CITY PLANNING COMMISSION

- APPLICATION:
1. Environmental Determination
 2. Amend Oak Park Community Plan from Shopping or Commercial to Medium Density Multiple Family (Sec. 13-B)
 3. Rezone 0.21± acres from General Commercial (C-2) to Medium Density Multiple Family (R-4) zone (Sec. 13)
 4. Lot Line Adjustment to merge two parcels (Sec. 66499.20½ Subdivision Map Act) (P83-273)

PROPOSAL: To develop a 12-unit apartment complex.

STAFF EVALUATION: Staff has the following comments and concerns:

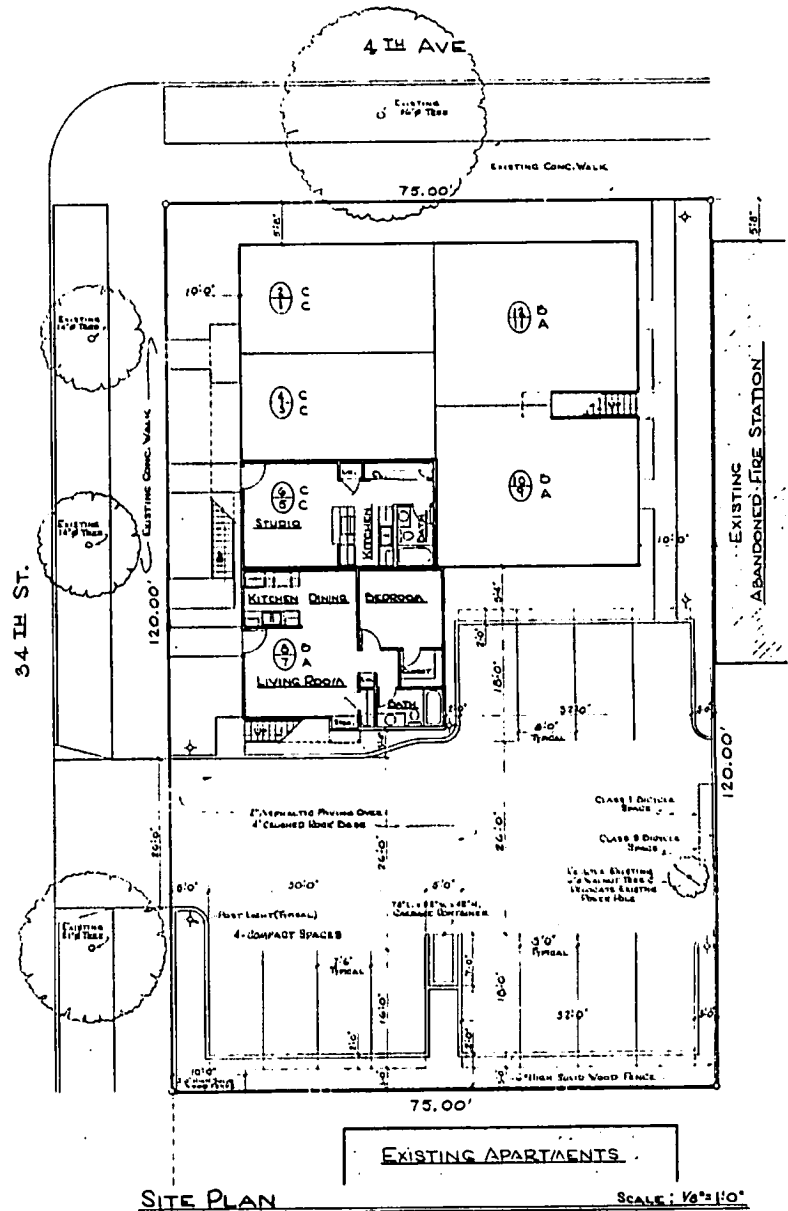
3. Staff notes that four and one-half feet of planting width along the south property line is not adequate for the proposed shade trees. A minimum planting width of six feet is necessary.

4. Although an area is designated for trash storage, no enclosure for the trash container is proposed. Staff suggests that a masonry enclosure with metal gate is essential as a visual screen and as a means of reducing the potential for scattering of trash.

- b. solid core exterior doors, with deadbolt locks and door viewers; and
 - c. shrubbery with thorns or prickly leaves placed along window areas.
6. The location of bicycle parking at the end of the drive obstructs the backing movement from the adjacent parking spaces. Staff suggests relocation of bicycle parking.

7. The Traffic Engineering Division notes that the proposed 20-foot wide driveway is substandard. A 24-foot minimum is necessary.
8. The City Engineer requests new deed description for the proposed merger.

- ✓ a. The planter along the southerly property line shall have a minimum planting width of six feet. The parking lot shall be adjusted to accommodate the increased planter width;

- ✓ e. Bicycle parking shall be relocated to the satisfaction of staff;
- ⓕ. The applicant shall submit the building design for Design Review/ Preservation Board review and approval;

- ✓ h. The premises shall be inspected by the Planning Director prior to issuance of occupancy permits to assure compliance with approved plans;
- ✓ i. The driveway shall meet Traffic Engineering Division requirements.

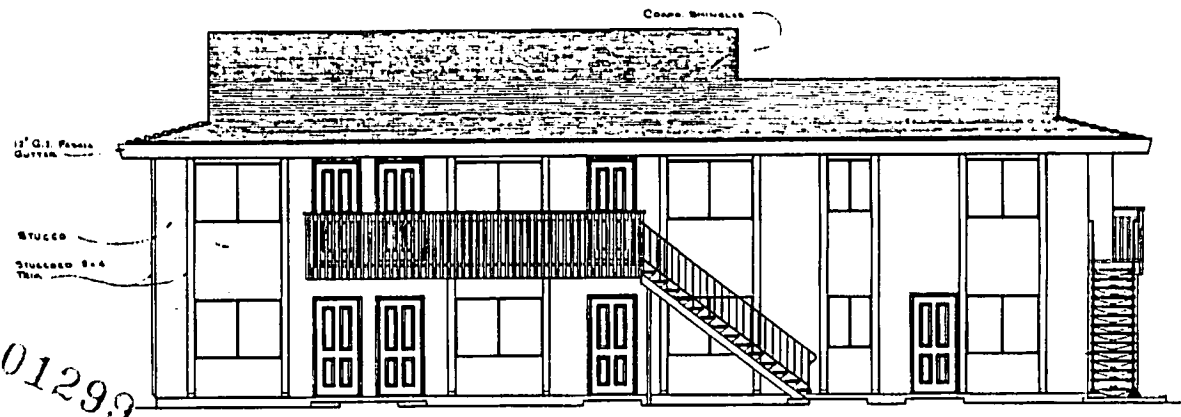
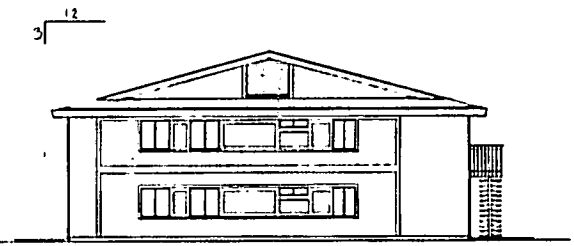
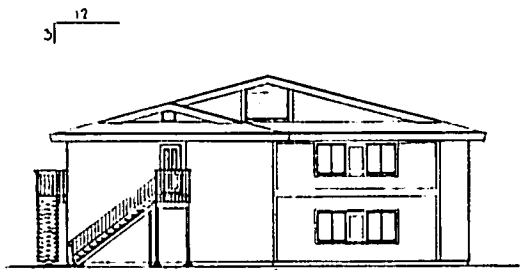
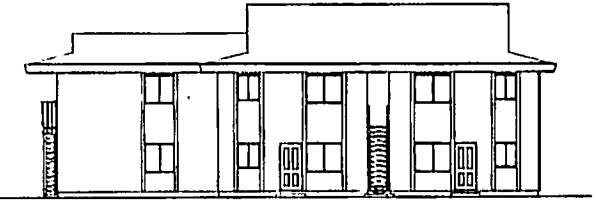
2. The Redevelopment Agency supports the proposed residential use which is consistent with the Agency's intent for residential on the entire City block on which the subject site is located. In addition, the Oak Park PAC has reviewed the project and indicated support of the project.
The Agency's concern is with respect to the building design. Its recommendation is for review by the Design Review and Preservation Board.
